JOB 35-1195
Comanche Peak Steam Electric Station

COMANCHE PEAK STEAM ELECTRIC STATION
CCP-40 VENDOR REVIEW

Allegation No. 6

QUESTIONS RELATIVE TO ALLEGATION NO. 6

Technical Report 462-81

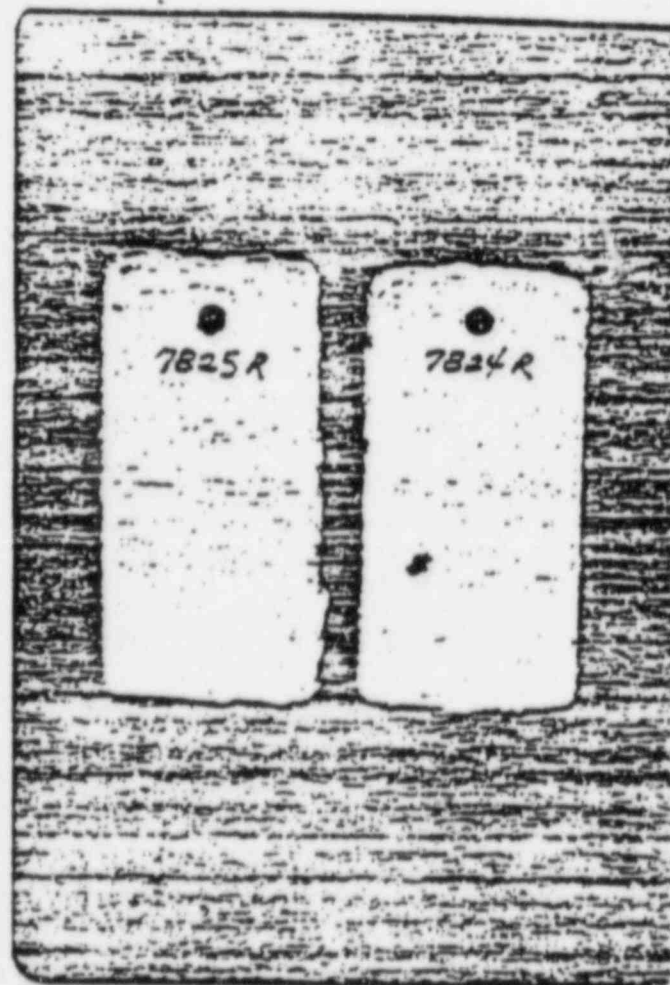
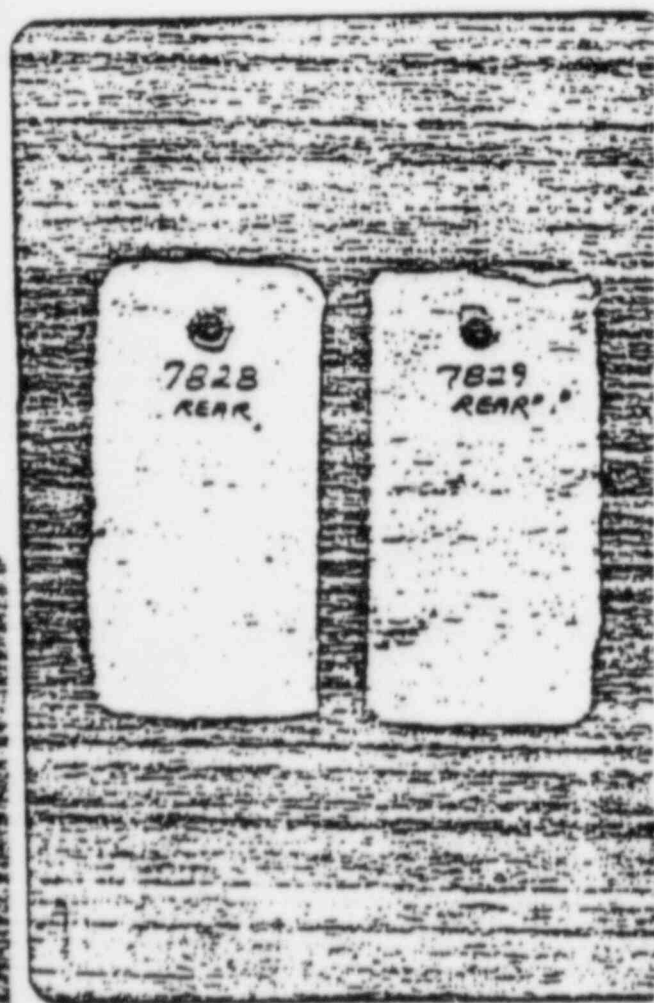
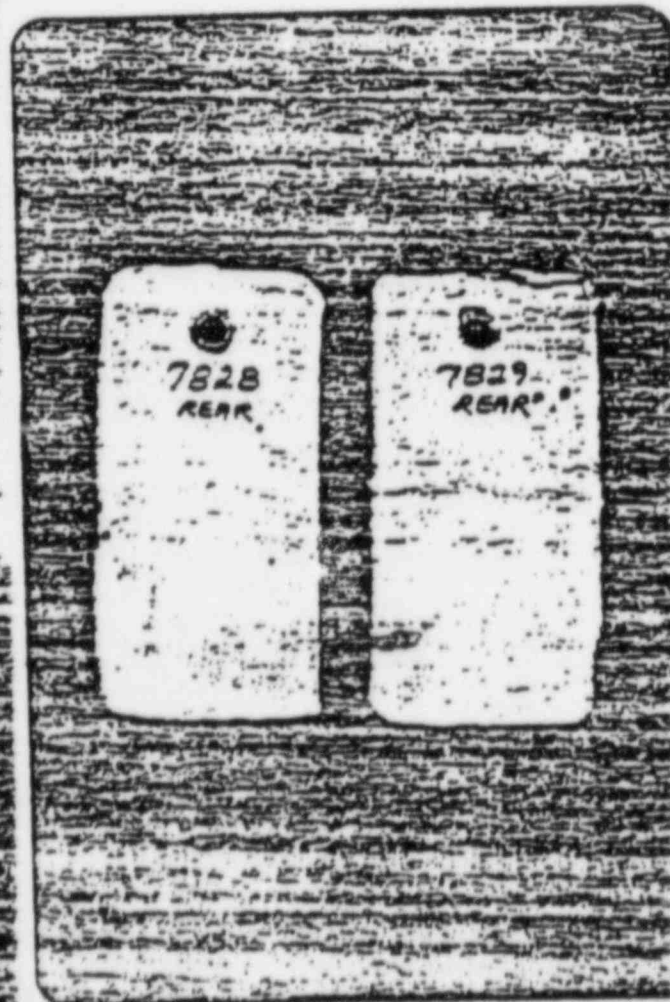
<u>Sample No.</u>	<u>DBA phase</u>	<u>Comments</u>
7828	spray	Front: coatings intact, no defects. Rear: blisters, #6 few.
7829	spray	Front: blisters, #2 medium. * Rear: blisters, #2 medium.

* *Imperial inspection of panels*

Front: #2-#4, few-medium (borderline)
